Re: [Appendix BBBBB-3: Technical Memorandum: Linear Diffuser Design Modification for the Proposed Huntington Beach Desalination Plant](#)

# Linear Diffuser Realignment Description

Figure 2. Modified 14-port linear diffuser design. Design is documented in Appendix BBBB-2 (November 27, 2018).

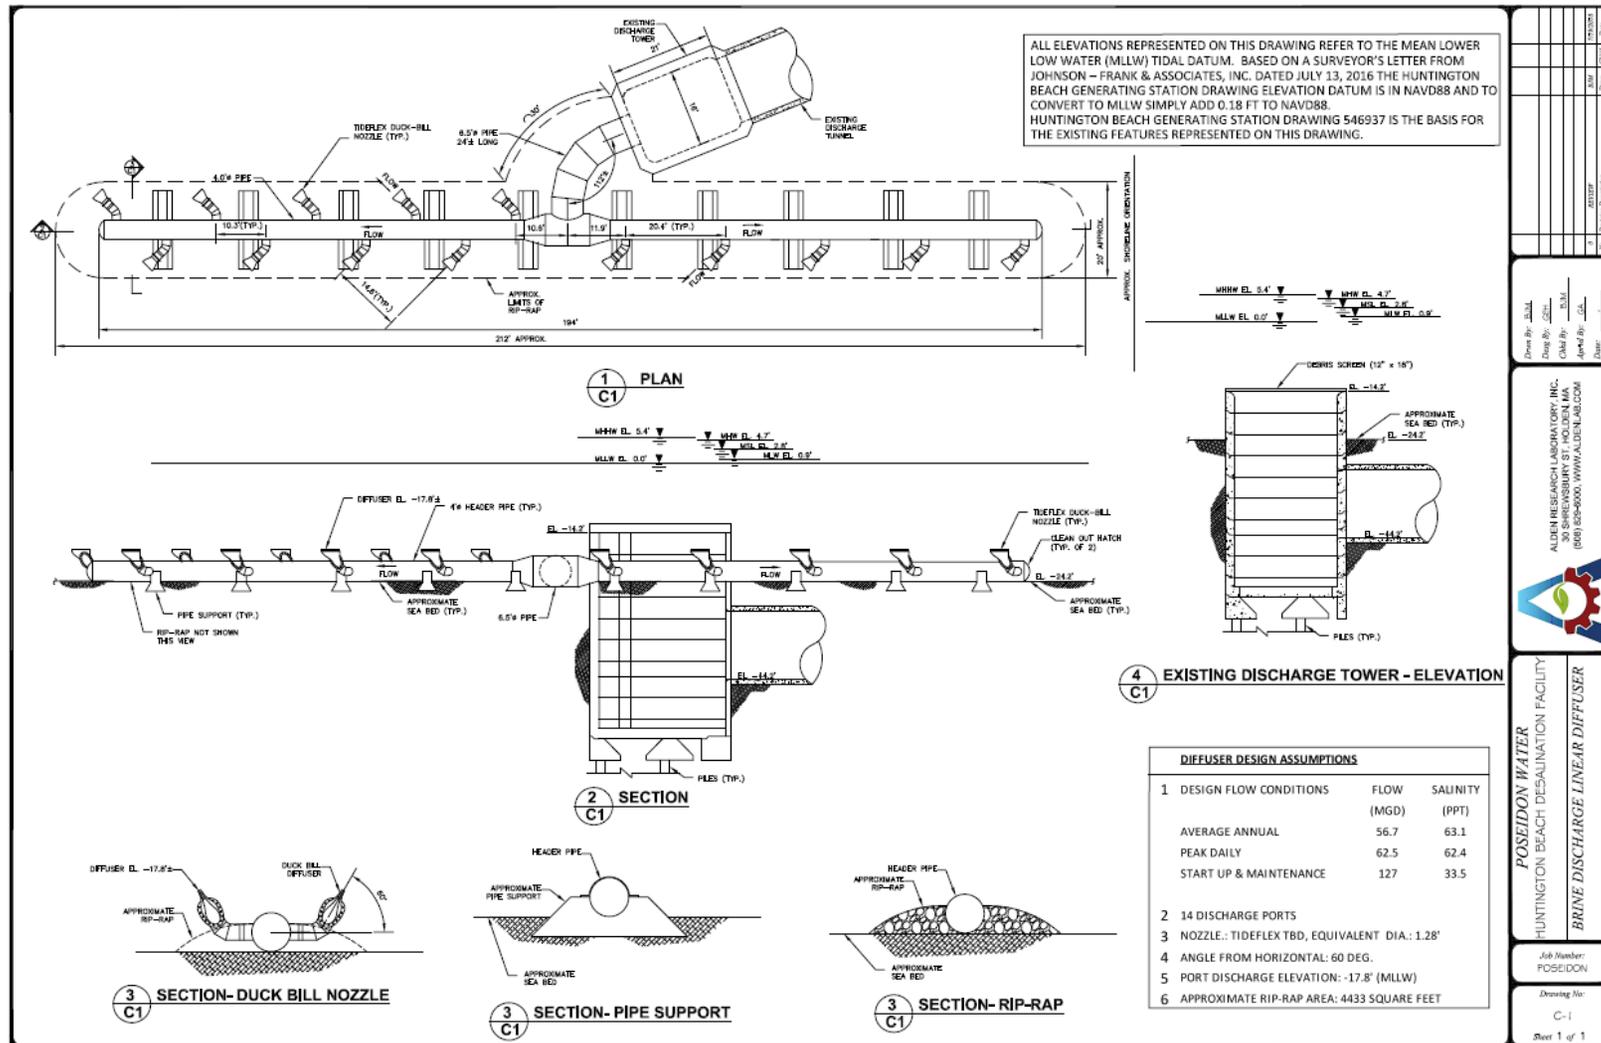
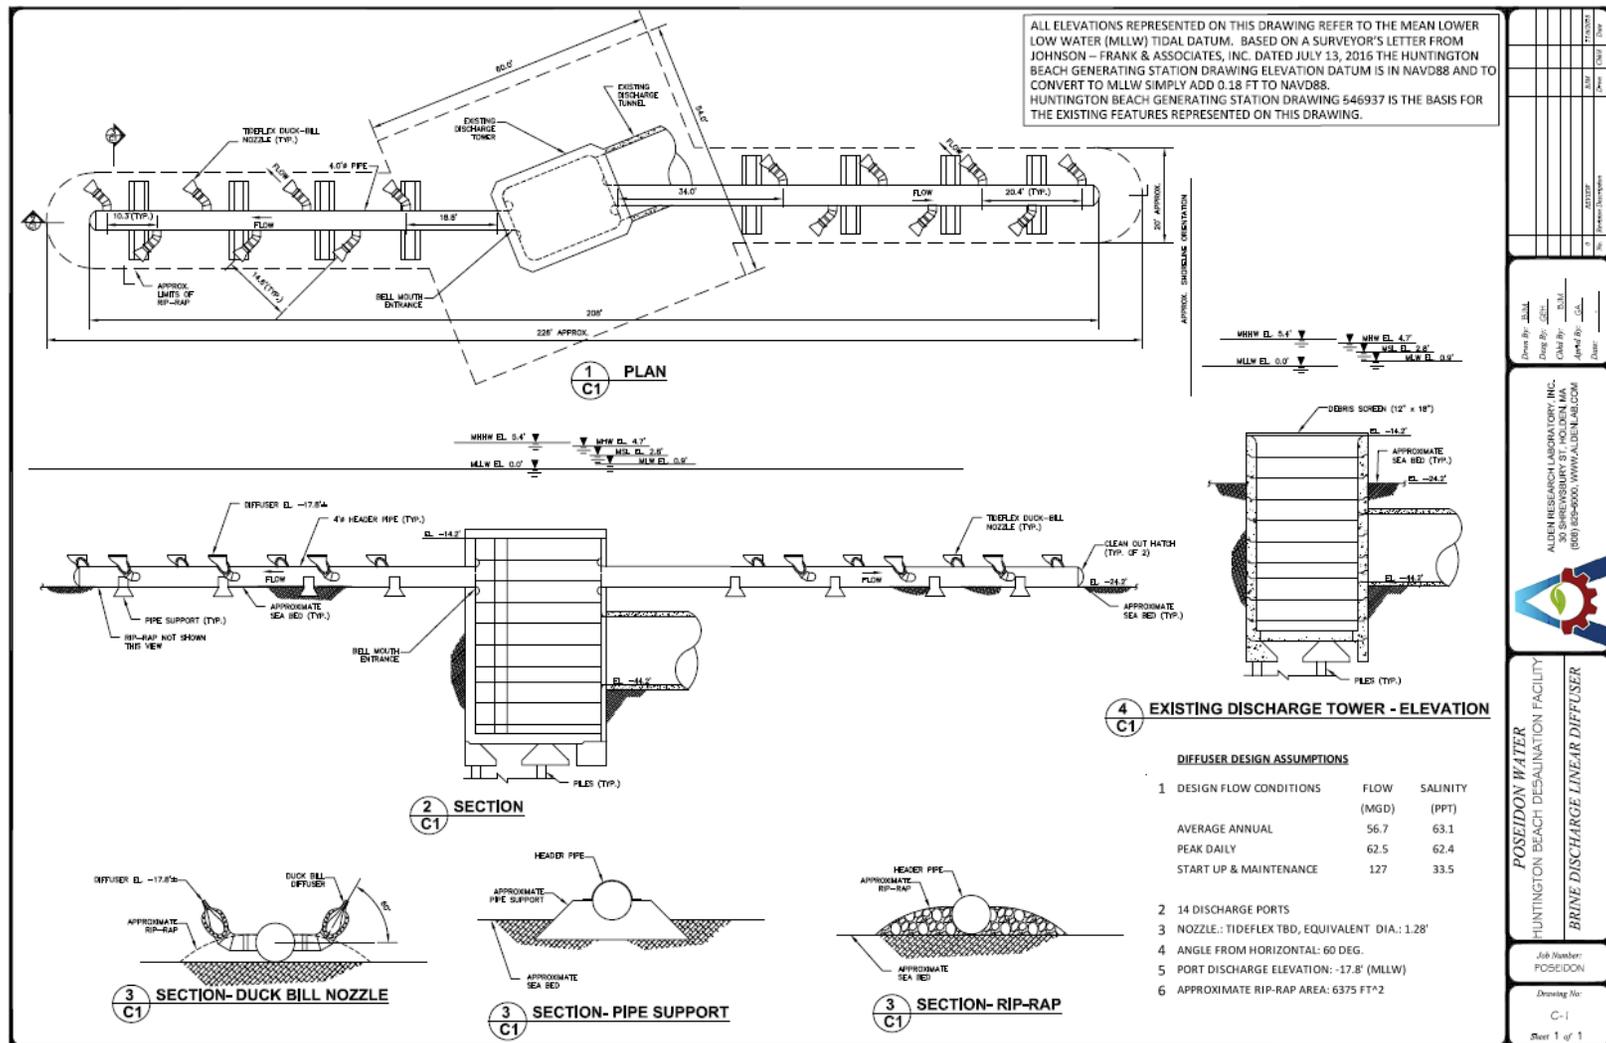
The only modification to the linear diffuser was in its alignment relative to the existing discharge tower to which it will be connected. Rather than utilizing a single continuous header for all 14 ports, the diffuser was split into two 7-port header sections with one section placed on either side (shoreward and seaward) of the existing discharge tower.

The initial and modified 14-port linear diffuser alignments are depicted in Figure 1 and Figure 2, respectively.

Per the Regional Board staff’s February 4, 2019 letter requesting additional clarification, an updated shearing analysis using the Roberts (2018a, b) methodology is unnecessary. The realignment of the diffuser with the discharge tower does not affect the number, diameter or angle of the diffuser ports or the volume and velocity of the discharged water. Consequently, the previously submitted shearing analysis is unchanged.

The initial 14-port linear diffuser for the HBDP was realigned based on a preliminary engineering-level design. The diffuser was realigned with the existing discharge tower, but no changes were made to the diffuser’s functional design (e.g., number of ports, port angle, port diameter, discharge velocity). This memo documents the realignment and is consistent with the description previously presented in Appendix BBBB-2. The modified alignment of the 14-port diffuser continues to represent a diffuser design for the HBDP based on the method described by Dr. Phil Roberts (2018a, b).
